PLANNING DIVISION STAFF REPORT

PREPARED FOR THE URBAN DESIGN COMMISSION

Project Address: 841 Jupiter Drive and 818 North Star Drive
Application Type: Planned Development (PD) Rezoning
Legistar File ID # [40142](#) and [40958](#)
Prepared By: Kevin Firchow, Planning Division
Report includes comments from other City agencies, as noted.
Reviewed By: Jay Wendt, Principal Planner

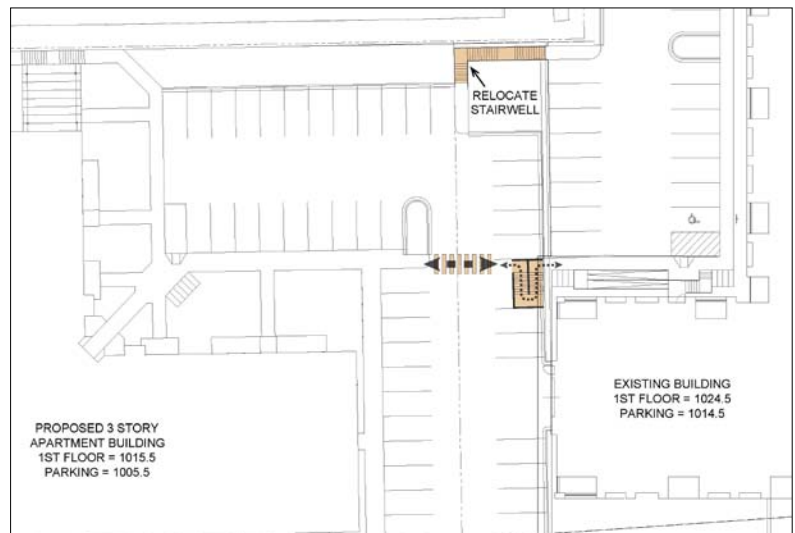
Further, the Planning Division does not believe the other connection, the stair connection at the back of the site, provides a safe or convenient path between the structures. Staff recommends that the rear stair connection be replaced with a different connection that aligns with the sidewalk behind the “Fusion Apartments” and the sidewalk in front of “The View.” (Graphic at the right shows staff-preferred location of a relocated connection.)
